HMMWV....

SMART START SYSTEM

CONTROL BOX BUZZ

S3 control box, NSN 6110-01-542-7901, replaces EESS control box

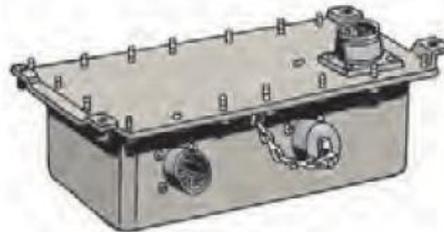
Some people didn't get the word that the S3 control box, NSN 6110-01-542-7901, is replacing the engine electrical start system (EESS) control box, NSN 6110-01-491-2158. The S3 was put into HMMWV production starting with serial number 255269.

When you order the S3, you'll get the S3 box and the temperature sensor. The biggest difference between the EESS and the S3 is that the S3 control box has three connector receptacles, while the EESS control box has only two. The plan is to use the third connector receptacle on the S3 control box in the future for troubleshooting and data logging.
